# DART+ West

## PUBLIC CONSULTATION NO.1 CONSULTATION FINDINGS REPORT

JULY 2021

Figure 4.3 Ashtown level crossing replacement options

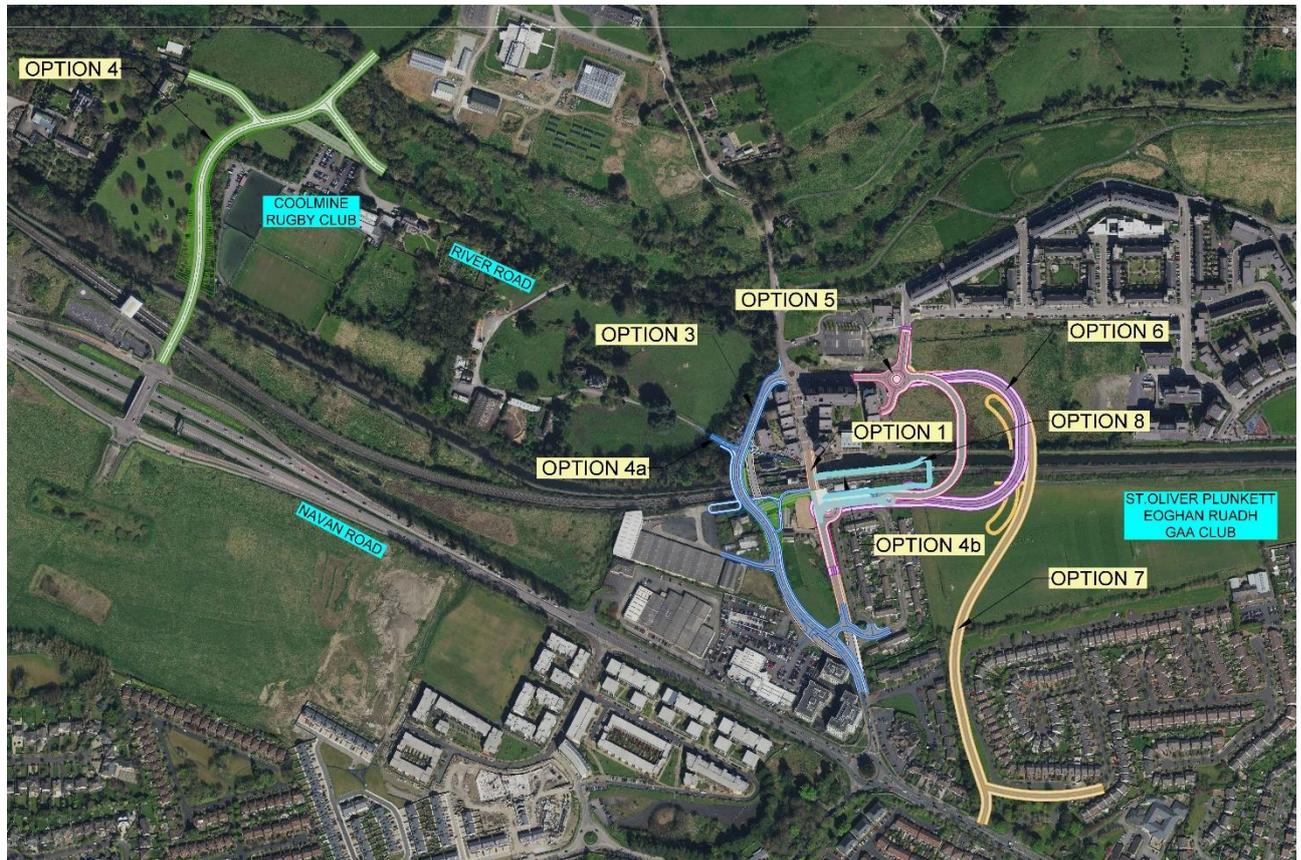
Respondents expressed community severance concerns due to the proposed circuitous diversion route for elderly residents accessing shops or the opposite platform at Ashtown Station. The concerns particularly relate to the difficulties that the local elderly and mobility impaired residents will face due to the gradient and length of the underpass.

Respondents expressed discontent at the removal of the amenity area and mature trees in Martin Savage Park for the proposed set down area at Ashtown.

Respondents have stated concerns regarding anti-social behaviour and the safety of the pedestrian under pass

Respondents have expressed concerns over the impact that further developments will have on the flooding in the Martin Savage Park area.

As the level crossing is required to be closed, Iarnród Éireann are providing an alternative route for pedestrians, cyclists and vehicular traffic as close to the existing level crossing location as feasible. The site of the existing level crossing is very constrained with commercial properties to the north, the protected structure to the north west and the station and residential properties to the southeast of the level crossing. The presence of the existing canal bridge and the footbridge along with the locks and the significant level differences between the canal and the rail significantly restrict the options available. The alternative pedestrian route will be designed for universal access.

IE have noted the concerns raised by the public at public consultation no.1 and the preferred option now includes a bridge with a lift and stairs will be provided immediately adjacent to the existing level crossing within Ashtown station. This accessibility bridge will be accessible to the general public as well as passengers during station hours. Further detail on this bridge is provided within the Option Selection Report and other material published as part of public consultation no. 2.

DART+ West is seeking to provide additional passenger capacity along the entire route and for all stations. Pick up and drop off and turning facilities are proposed at Ashtown because DART+ West is creating a cul-de-sac due to the level crossing closure. The proposals for efficient and effective turn back of vehicles is consistent with road design guidelines and standards. DART+ West must provide sufficient improvements for all users, be they vehicle users, cyclists and pedestrians including mobility impaired users at Ashtown to ensure proper design and sustainable development for the project.

The comments have been noted regarding the loss of green space and Iarnród Éireann have committed to undertaking further design development of the emerging preferred option.

The underpass will be designed in order to maximize the openness of the structure and to enhance the feeling of safety. The structure will only be 30 metres in length and will be approximately 5 metres high. There will also be public lighting provided through the underpass. As this will be the main public road there will be a high level of usage thereby reducing the likelihood of antisocial behaviour. Iarnród Éireann have committed to reviewing the integration of CCTV usage at the underpass.

A Flood Risk Assessment (FRA) is currently being prepared for the DART+ West Project. The FRA will analyse areas identified as liable to flood and advise on appropriate flood risk management measures as per "The Planning System and Flood Risk Management Guidelines for Planning Authorities" (OPW 2009). Initial findings from the FRA will be included in material published as part of public consultation no.2.

**Figure 4.4 Proposed depot location west of Maynooth**

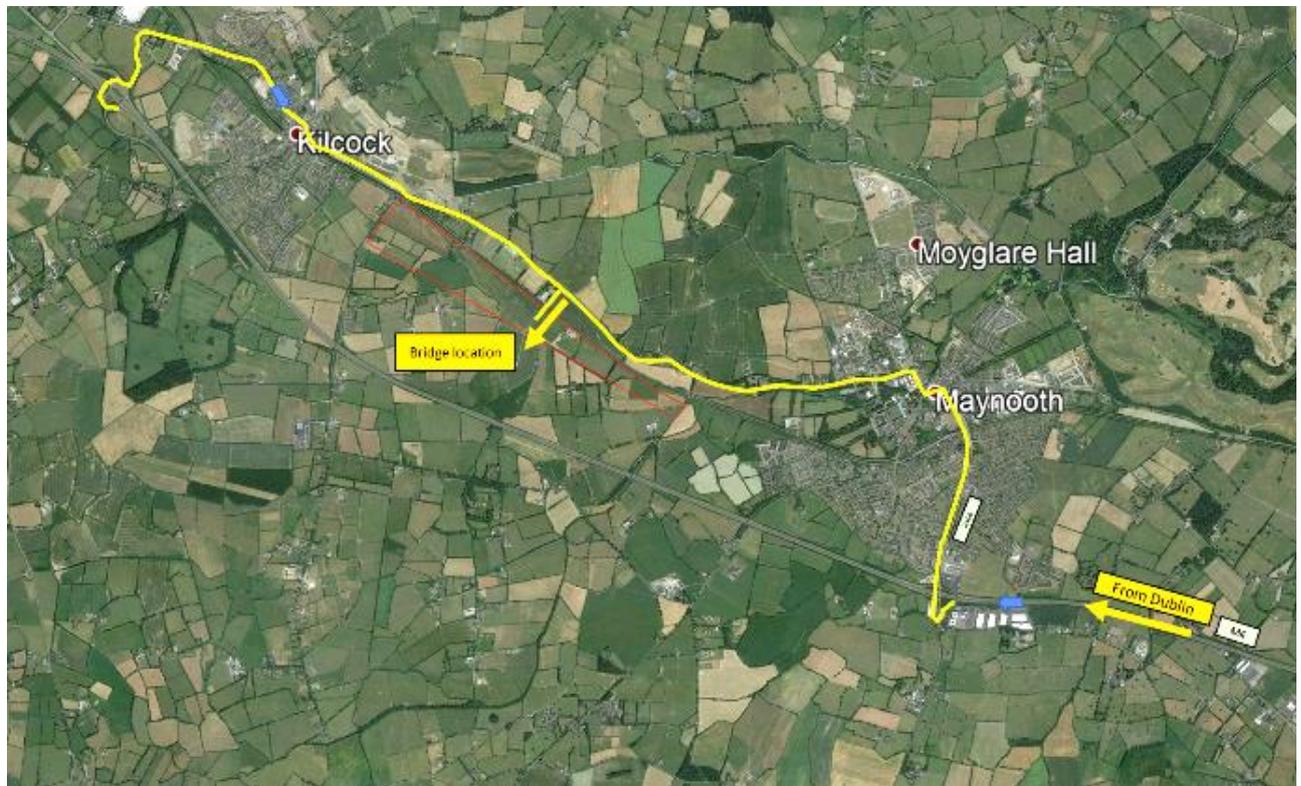
Respondents highlighted concerns about road safety and the adverse impacts that heavy goods vehicles will have on traffic and access to the towns of Maynooth and Kilcock.

As part of the options development for the depot area four possible access routes were assessed under the Multi Criteria Assessment (MCA) process to determine the optimal option. Option 1 discussed the possibility of changing the road in question (Connaught Street) to a one-way traffic flow. Following completion of the MCA it was determined that option 4 which involves an access route off the R148 was determined to be the emerging preferred option. The emerging preferred option for the depot layout includes for an emergency access point located south east of the bend in Connaught Street as it turns south. Slight road widening works may be required to the bend to improve road safety. It is not envisaged that Connaught Street will need to be one-way traffic to facilitate the emergency access point.
